## PUD-1917 – FORMAL OPPOSITION PROTEST

### Oklahoma City Planning Commission

I have received notice of a PUD application (the "**Proposed PUD**") submitted by Sitelab Land Partners LLC ("**Sitelab**") for a development located at 5500 NW 164<sup>th</sup> Street (the "**PUD Site**") under Case No. PUD-1917. I serve as the President of Monarch Ridge HOA, Inc., the homeowner's association for the residents of the Monarch Ridge neighborhood ("**Monarch Ridge**"). Monarch Ridge is a 67-home single-family residential neighborhood located directly to the east of the PUD Site. On behalf of Monarch Ridge HOA, Inc. and the residents of Monarch Ridge, I hereby submit this letter in formal opposition to the Proposed PUD as in its current form. The rationale for this objection is set forth as follows:

## PUD 1917 - Lot Plan Detail

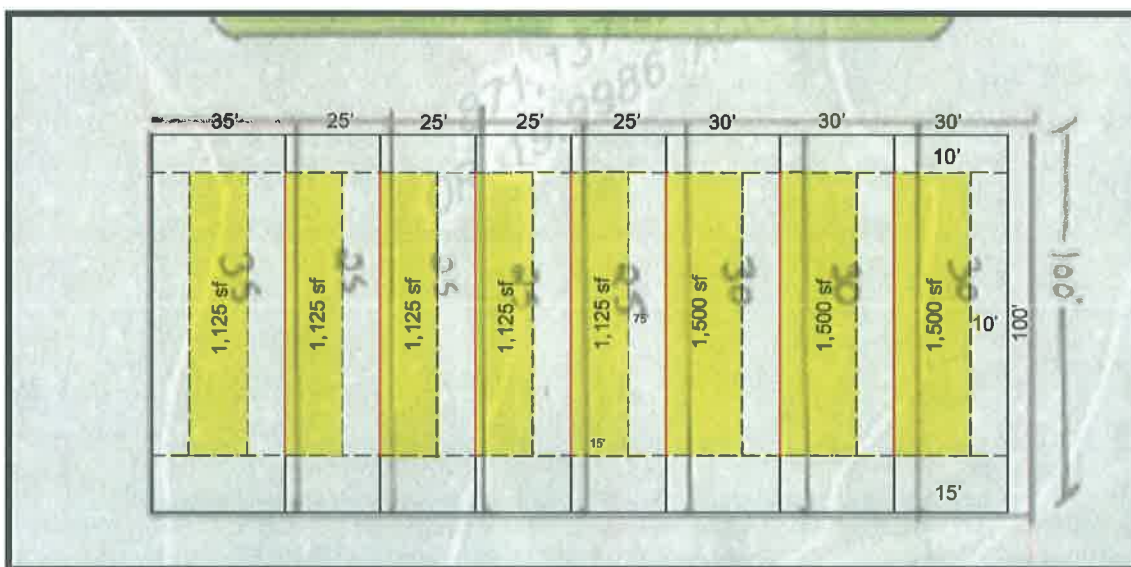
lot width from **40' (50' Corner) to 25' minimum**. These reductions from minimums will result in **extremely narrow lots and allow for a very limited number of design planning options and will be incompatible with established existing context**. Even with variation in lot scale, only 7 of the proposed 140 lots meet even the City's minimum lot requirement of 40'x100'. Please see **Attachment B** for graphical information further illustrating this point.

Buildable Lot Area:  
25' x 100' Lot - 1,125 sf (15'x75')  
30' x 100' Lot - 1,500 sf (20'x75')  
\*35' x 100' Lot - 1,125 sf (15'x75')

Red indicates where Structure sits directly on Property Line and is thus subject to IRC 2015 Table R302.1(1) Exterior Wall Fire Rated Assemblies and No Projections or Openings (Windows/Doors) Allowed

**Proposed PUD Development**

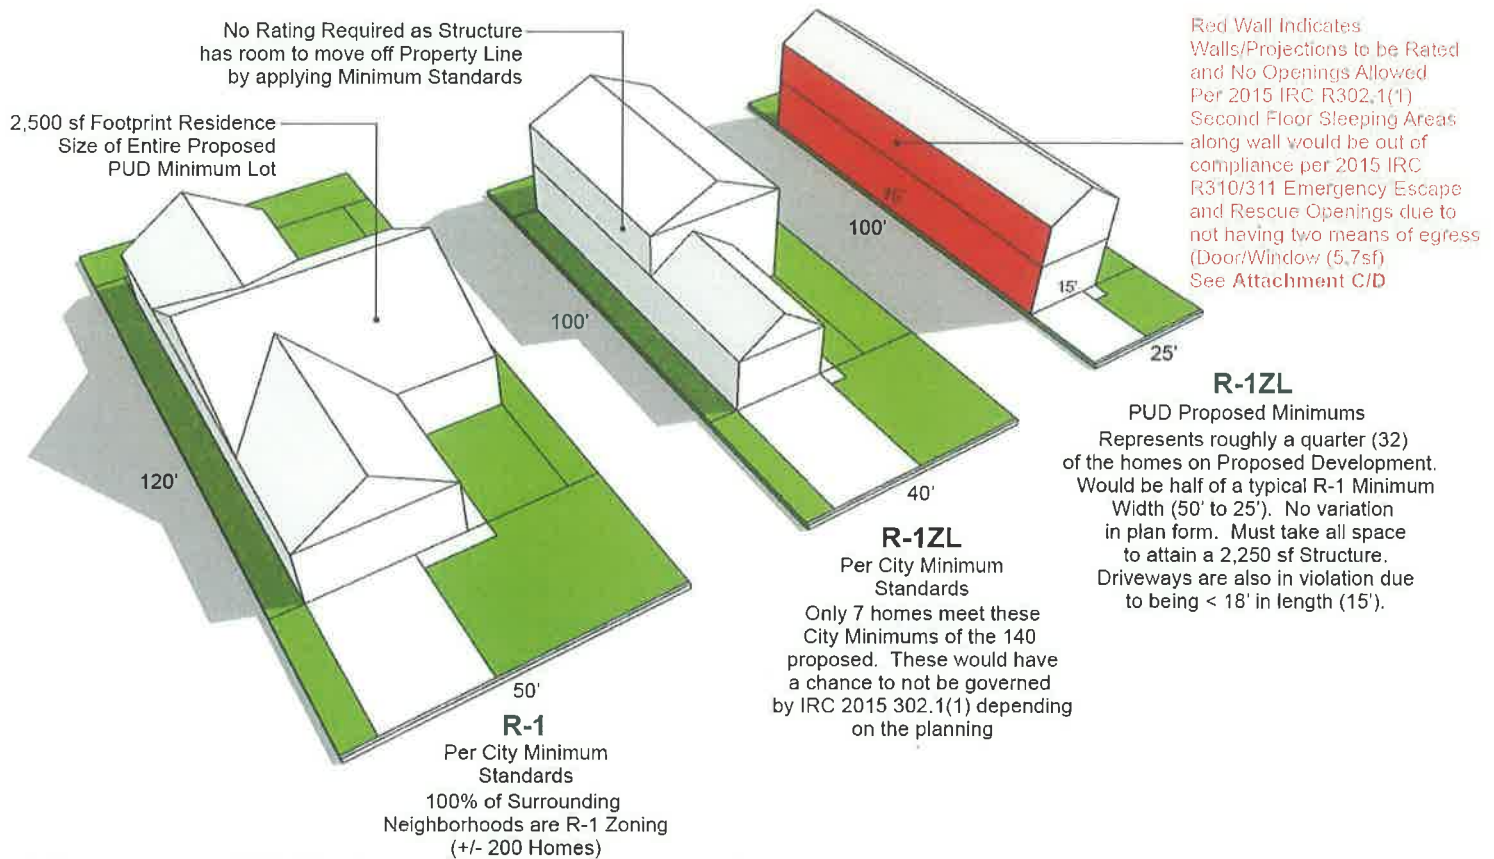
With the Proposed PUD using R1-ZL as the basis of design, **2015 International Residential Code Chapter R302.1(1)** requires any structure placed along a property line adhere to a **two-way 1-hour rating of the entire wall assembly**. Additionally, **no openings in walls (windows/doors) are allowed within 3 feet of property line**. This will significantly impact the design planning as it will **require an entire side of a home to become a completely blank wall** as it sits along the property line. Without these provisions in place, it will create a grave fire danger risk for the development and surrounding areas. No reference to these standards is given within the proposed PUD. This has been confirmed through conversations with the City of OKC Fire Protection Specialist. See **Attachment C and D** for additional information.

With the removal of any openings along the fire wall, **any bedrooms located along said wall will not have windows, therefore they will not achieve the required 2 means of egress out of every habitable space per 2015 IRC R310 and R311**. The review of these plans in detail is crucial for compliance prior to construction.

Red indicates where Structure sits directly on Property Line and is thus subject to IRC 2015 Table R302.1(1) Exterior Wall Fire Rated Assemblies and No Projections or Openings Allowed

## ATTACHMENT E Zoning Classification

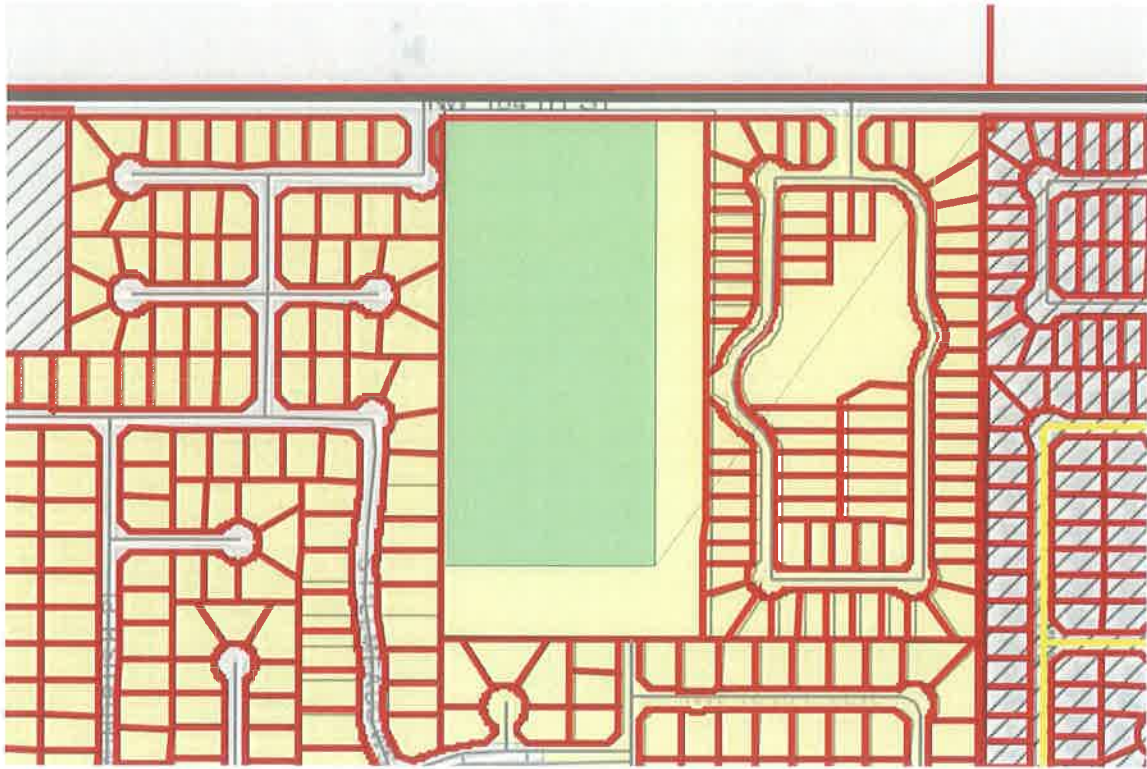
The Proposed PUD states that the PUD Site is currently zoned as an AA Agricultural District. However, only part of the PUD Site is zoned as AA, **with approximately 5 acres along the eastern boundary being zoned as R-1**. See **Attachment E**. An open records request has been made to the City of Oklahoma for the re-zoning application for Monarch Ridge, but we believe it is very likely that the additional area outside of the Monarch Ridge neighborhood (and within the PUD site) was **intentionally zoned R-1 to ensure compatibility of the neighborhood with Monarch Ridge** (and we believe the requested documentation will show that intent). Not only does the Proposed PUD wrongfully classify the zoning of the PUD Site, but it fails to account for the fact that approximately 25% (or 5 acres of the 20 acre PUD Site) is currently zoned R-1; the same zoning as neighboring subdivisions Monarch Ridge and Still Meadows.
